Remarks/Argument

Response to Examiner's Remarks in Detailed Action

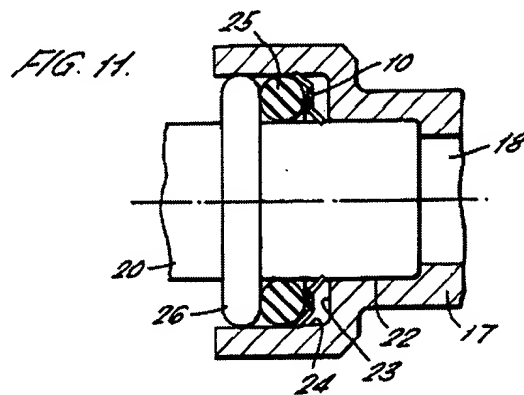
The Examiner refers to element 26 in Guest as the “compression gland,” with reference to Guest’s Figure 11. Figure 11 of Guest is reproduced below:

In this image, the element 26 appears to be a band affixed to the first male pipe portion. The language used by Guest to refer to this element is “encircling bead 26” or simply “bead 26”. (See column 3, lines 35 and 37). See also (for example) Figures 13-15 of Guest, in which the bead is shown in the same static position on the pipe 20, regardless of stage of installation or insertion into the bell. Applicant contends that those in the industry would understand each of Figure 11 and the text cited above, to refer to a “weld bead” configuration. In the piping industry, it is common in some applications to permanently affix a raised surface in the form of an affixed ring welded about the spigot. This is frequently accomplished by welding a ring to the spigot surface, or simply depositing a circumferential bead of weld metal about the spigot. In operation, the spigot is then inserted into the female pipe portion beyond the location of the band or bead, and then a blocking device is somehow affixed. It is clear that this is the intended function of the bead 26 in Guest, as evidenced not only by the understanding in the industry, but also by fact that Guest itself suggests that the bead 26 is properly considered permanently and

Understanding this known methodology and structure for locking pipes, the band 26 referred to by Guest appears to be just such a weld bead or affixed band. Significantly, this bead is understood to be affixed directly and immovably to the spigot. This is not a compression gland, and does not perform the function of a compression gland. Being affixed permanently in immovable relationship to the spigot, the bead cannot move as a compression gland does. Moreover, the bead is permanently affixed to the spigot, rather than being "securable to the second female pipe portion" as required by the claim.

FIG. 1
PRIOR ART

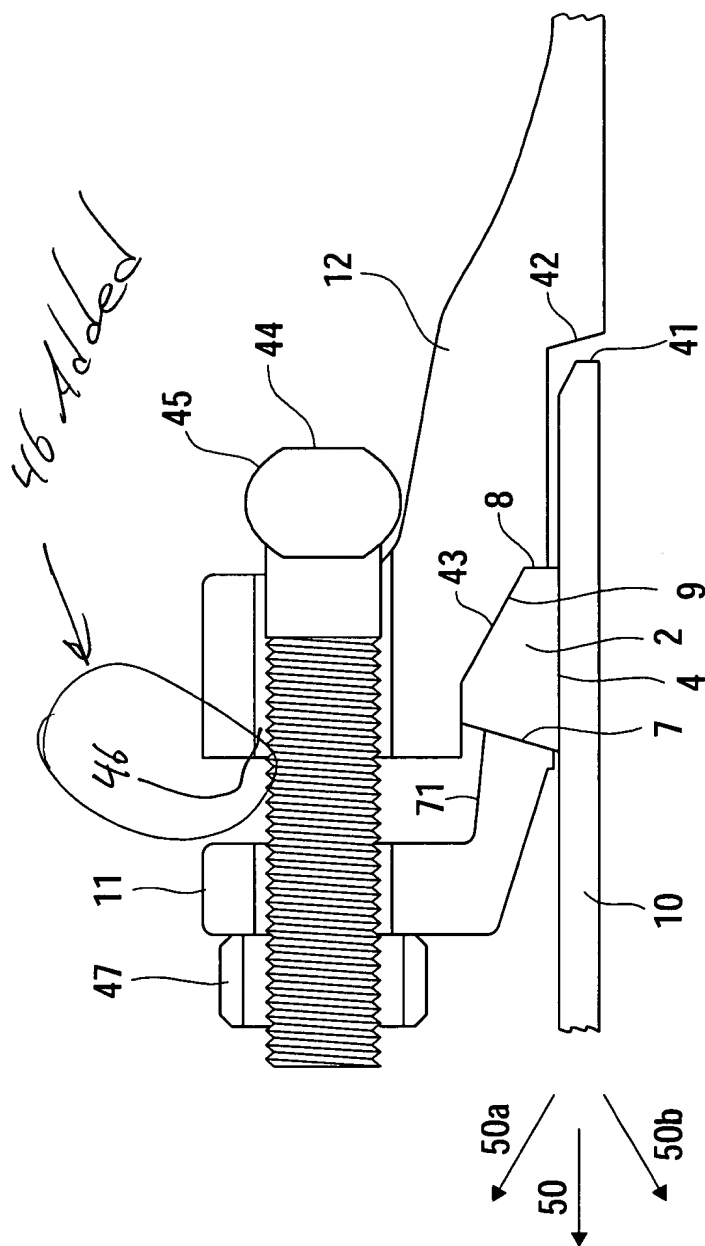
Figures 1 and 4: Reference numeral 46 has been added. Figure 4 shows biting of the segment into the bell.

FIG. 2

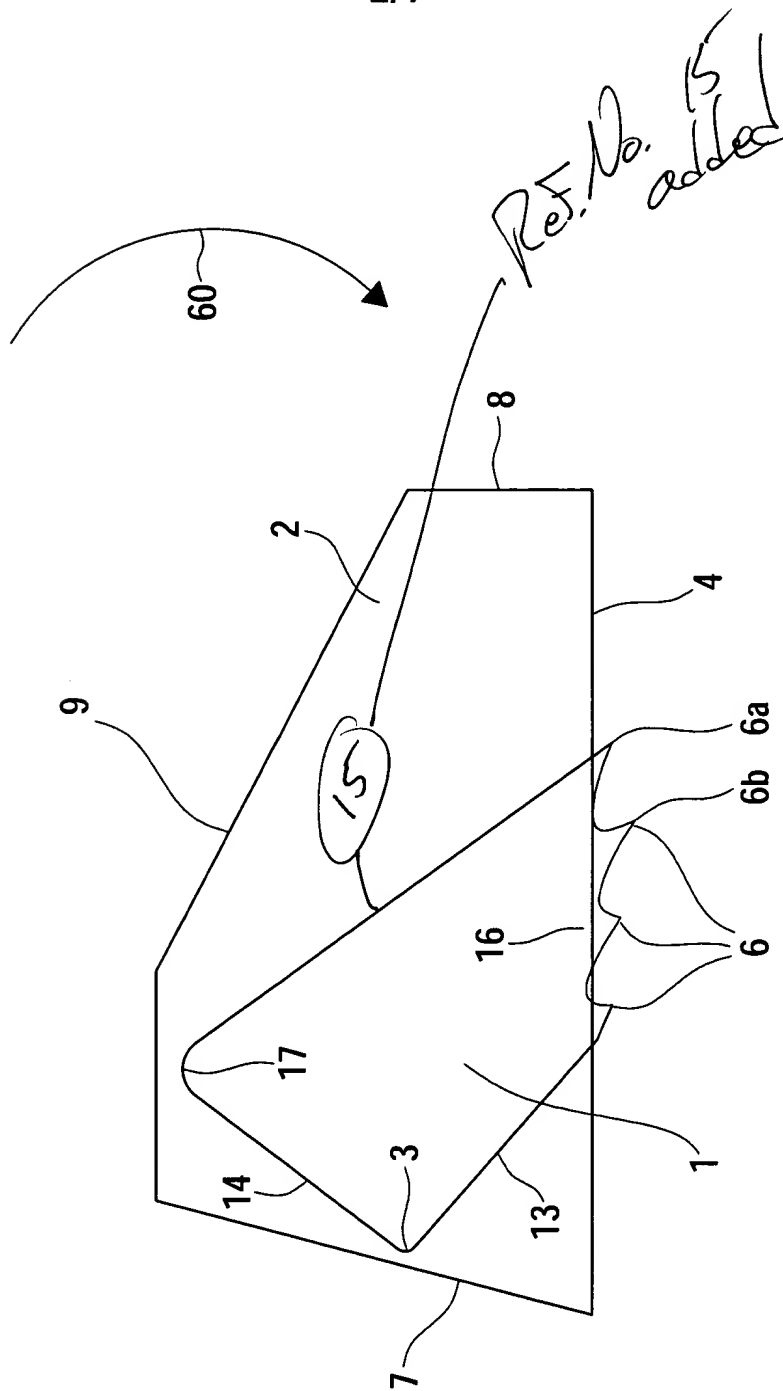
Figure 2: Reference numeral 15 (shown in Figure 7) has been added for ease of the reader.
